# HISTORIC AND DESIGN REVIEW COMMISSION

Agenda Item No: 26

**HDRC CASE NO:** 2015-023  
**ADDRESS:** 415 E PARK AVE  
**LEGAL DESCRIPTION:** NCB 1752 BLK 5 LOT E 25 FT OF 6 & W 13.29 FT OF 7  
**ZONING:** R4 H  
**CITY COUNCIL DIST.:** 1  
**DISTRICT:** Tobin Hill Historic District  
**APPLICANT:** Jennifer Boone  
**OWNER:** Manuel Mendoza, Yolanda Mendoza  
**TYPE OF WORK:** New construction of 2-1/2 story residence  
**REQUEST:**

**BOONE RESIDENCE**  
415 East Park Avenue San Antonio, TX 78212

**FOUNDATION & 1ST FLOOR FRAMING PLANS**

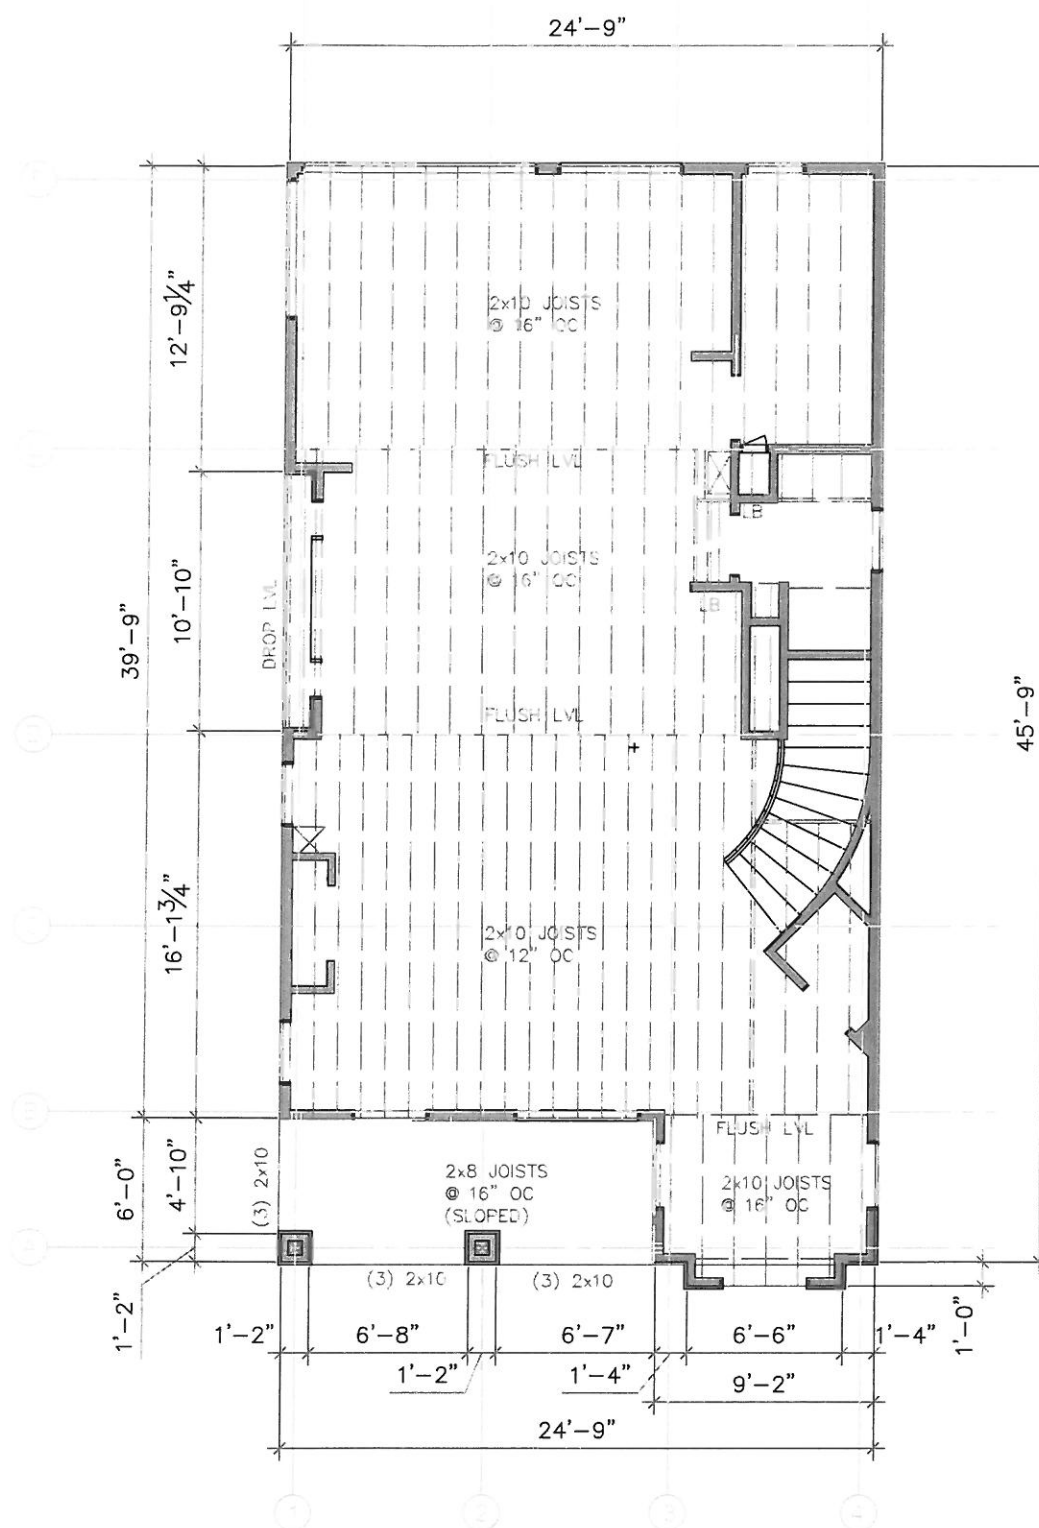
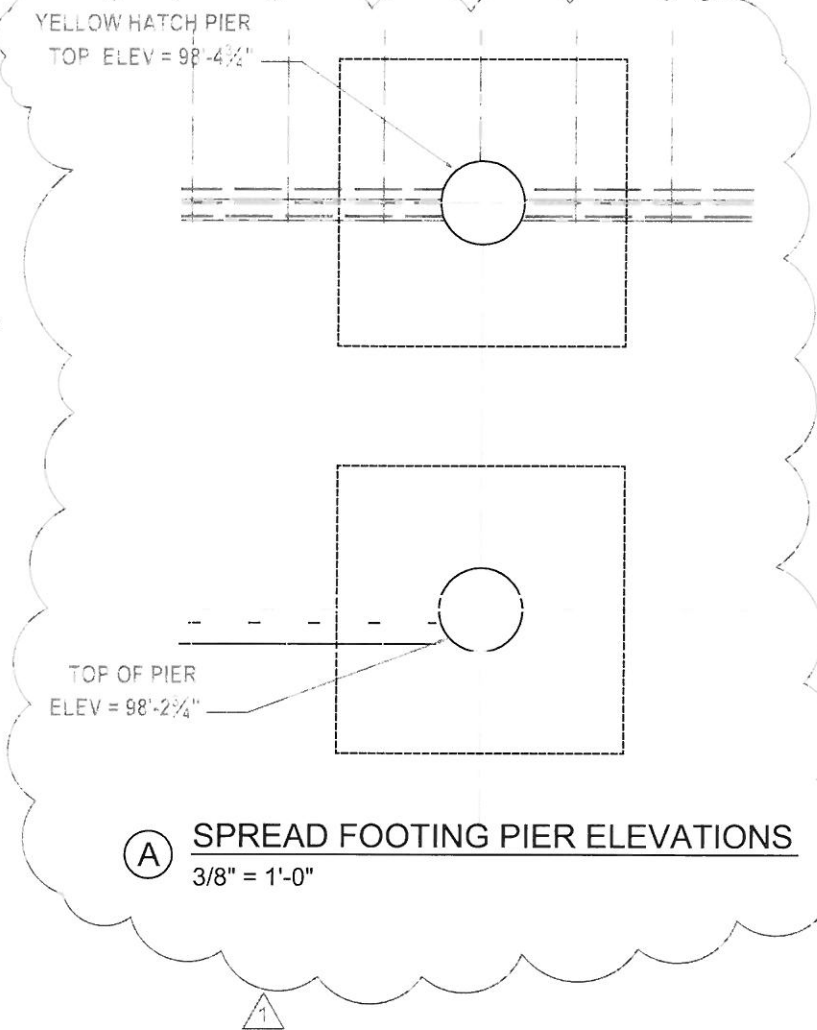
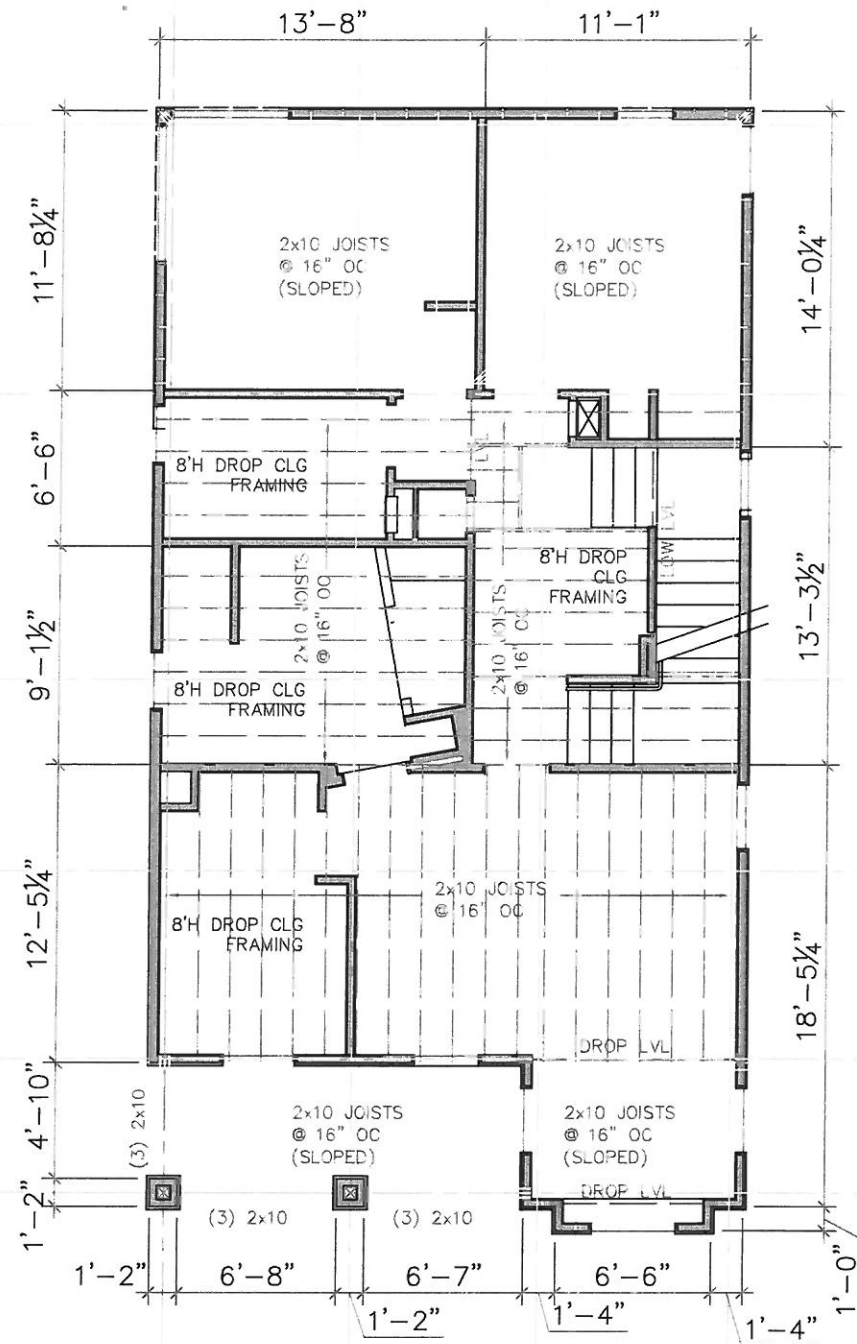
3 JUN 2015  REVISED TOP OF PIER ELEVATIONS & DETAIL. REVISED SIZE OF PERIMETER BEAM AS INDICATED

# EXTERIOR ELEVATIONS

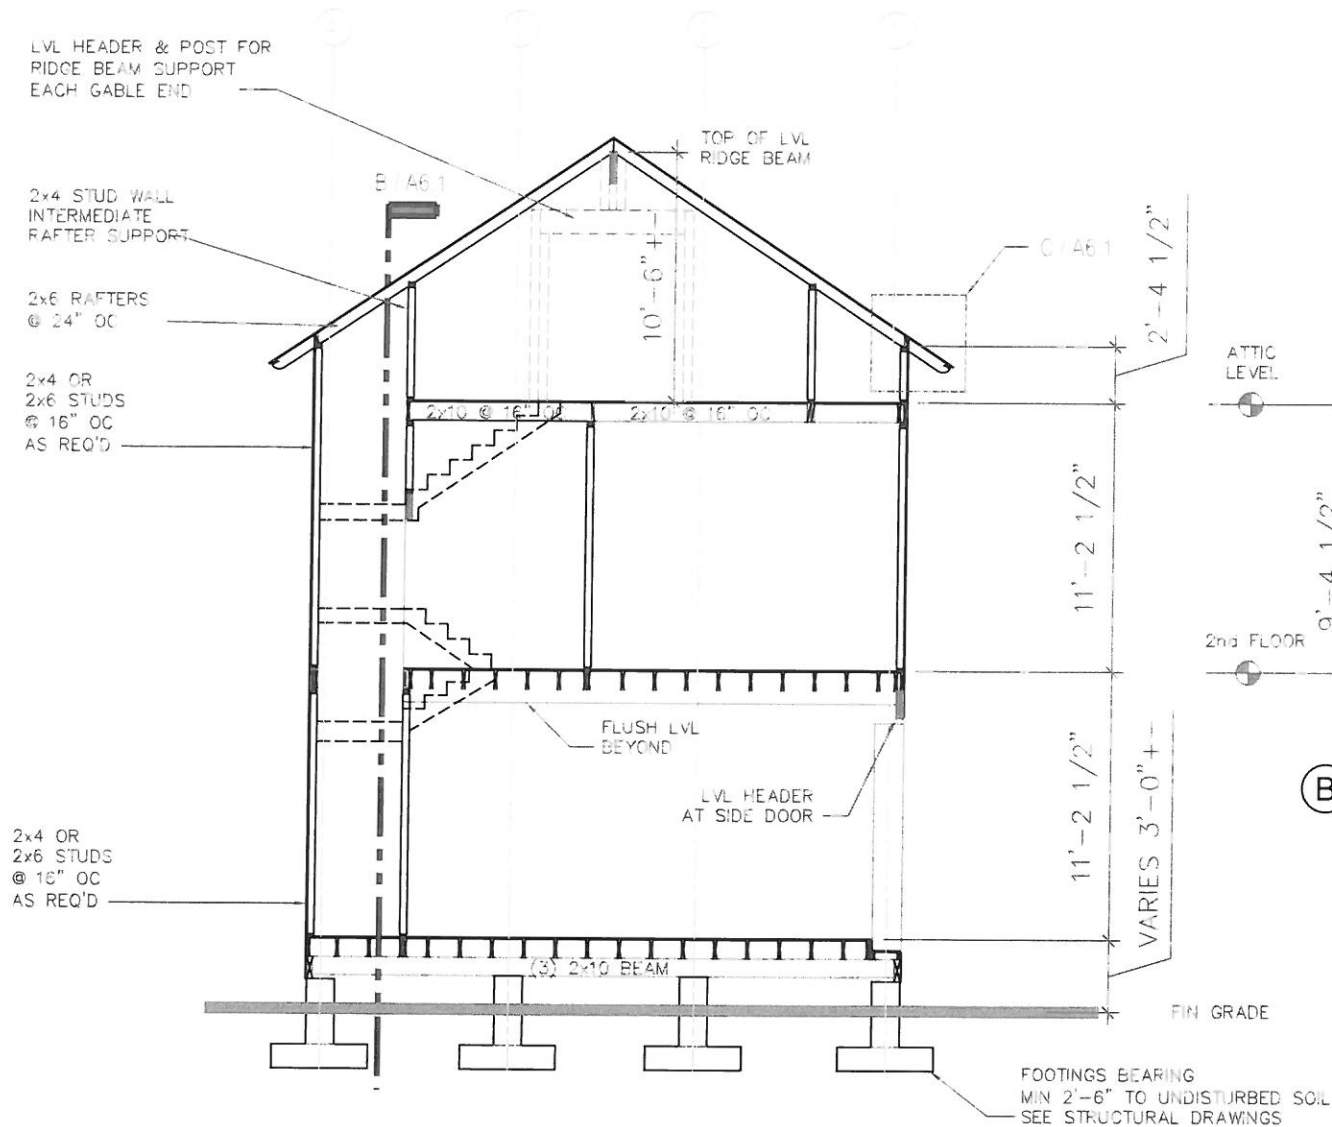
- c. The case was reviewed by the Design Review Committee on June 23, 2015. The Committee was satisfied with the revised fenestration pattern but expressed concern regarding the proportions of the columns, using false divisions on the windows and the small mansard roof at the front elevation. The Committee recommended making the column tapers less dramatic, using one over one windows and simplifying the mansard hood.

- i. Consistent with the Guidelines for New Construction window and door openings should have a similar proportion of wall to window space as typical with nearby historic facades. Windows, doors, porches, entryways, dormers, bays, and pediments shall be considered similar if they are no larger than 25% in size and vary no more than 10% in height to width ratio from adjacent historic facades. The proposed fenestration pattern is consistent with the guidelines. However, the proposed false divided light pattern on the windows is not consistent with historic windows and should be avoided.

- k. According to the Guidelines for New Construction, new buildings should be of their time while respecting the historic context. In addition, consistent with the Secretary of the Interior Standards for Rehabilitation #3, changes that create a false sense of historical development, such as adding conjectural features or elements from other historic properties, should not be undertaken. The proposed craftsman columns and mansard roof on the front elevation create a false sense of history and are not an accurate representation of the building's architectural style or time of construction. Simplified architectural detailing that does not compete with its historic context would be more appropriate.

- l. Consistent with the Guidelines for New Construction, details should be simple in design and should complement, but not visually compete with, the character of the adjacent historic structures or other historic structures within the district. The proposed massing for the front façade is vertical in design which is consistent with other two story historic homes within the district. However, the proposed porch columns break the verticality of the façade and are not consistent with other vertical elements on the elevation. Simplified columns that remain continuous from the first floor to the top of the second story porch would be more appropriate.

COMMENTS/CONCERNS: MG - resolves questions about penetration, gable roof & roof top balcony are resolved. TC - are these the windows you are proposing? MM - Yes, TC - more appropriate to remove divisions. BF - columns? MM - simplified top of columns, we don't want to change. TC - not opposed to tapered column but proportions look don't look right. MM - manual roof cover tops bump out, could be a small hip or shed but wanted to give it more detail. TC - hip or shed would be more appropriate.

- a. One over one windows with no divisions are used
- b. Architectural detailing is simplified at porch columns and mansard roof cover.
- c. Front porch columns run continuously through the top of the second story porch
- d. Specifications for appropriate windows and doors are submitted for review
- e. The proposed cement board siding has proper dimension, finish and texture
- f. Standing seam roof has panels 18-21" wide, seams no taller than 2" and a low cap or munched seam with no ridge vent.

MAKE COLUMN TAPERS LESS DRAMATIC, NO

APPLIED MULLIONS @ WINDOWS, MODIFY WINDOW HOOD @ 2nd FLR

**(B)** GABLE VENT ELEVATION - Typical Front & Rear Elevation  
3/4" = 1'-0"

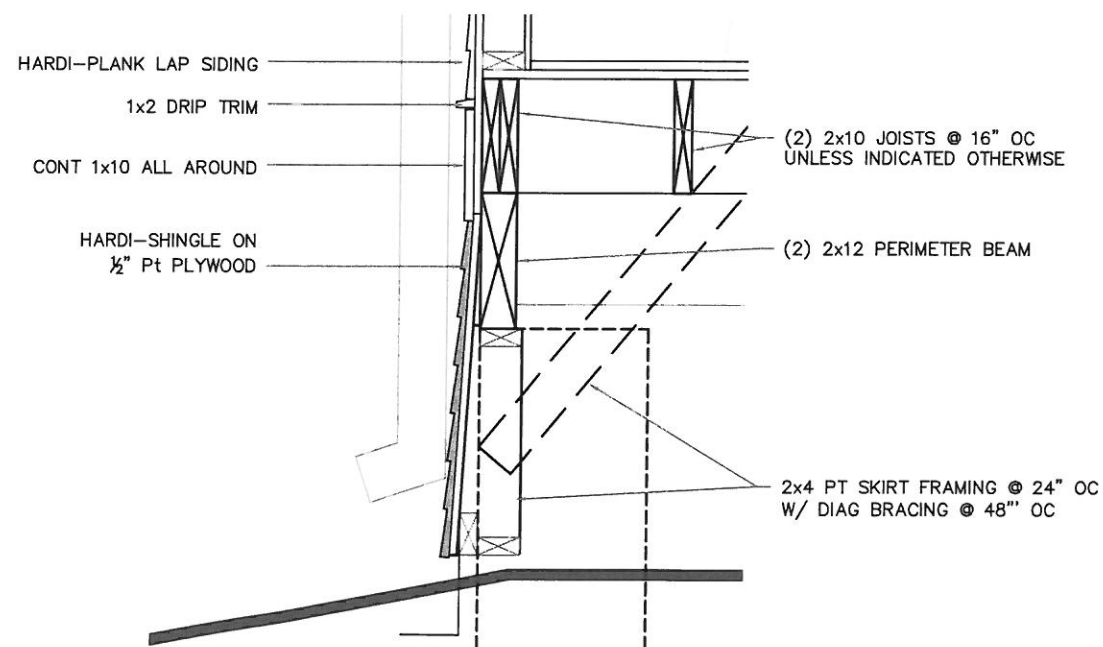
**Additional information on roof gable to show vent detail**

*See Detail B/A6.4 for additional information requested.*
